Title projectTitle projectVersion			
Size Letter	Number projectdocumentNumber	Revision projectDocumentRevis	
Date:	2/13/2016	Sheet * of *	
File:	C:\Users\...HE280PCB.SchDoc	Drawn By: projectDesigner

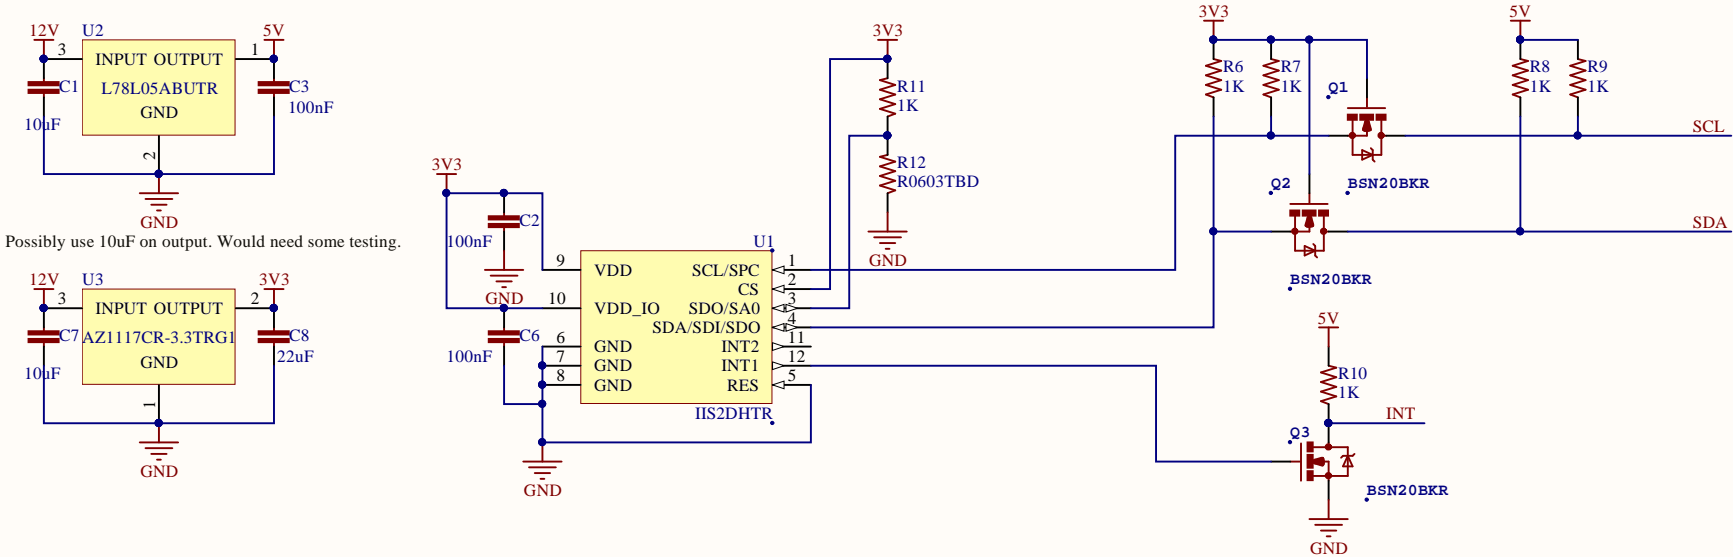
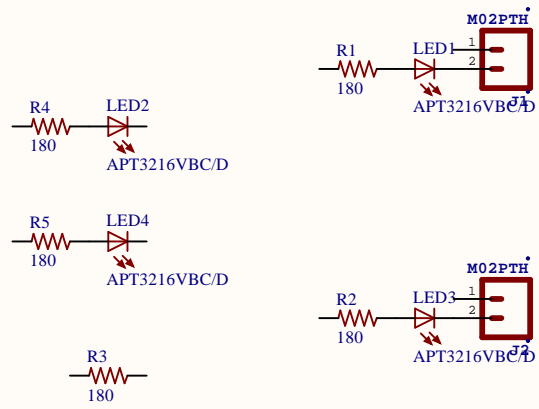
Possibly use 10uF on output. Would need some testing.

These LEDs are run from 12V and the resistors need changed
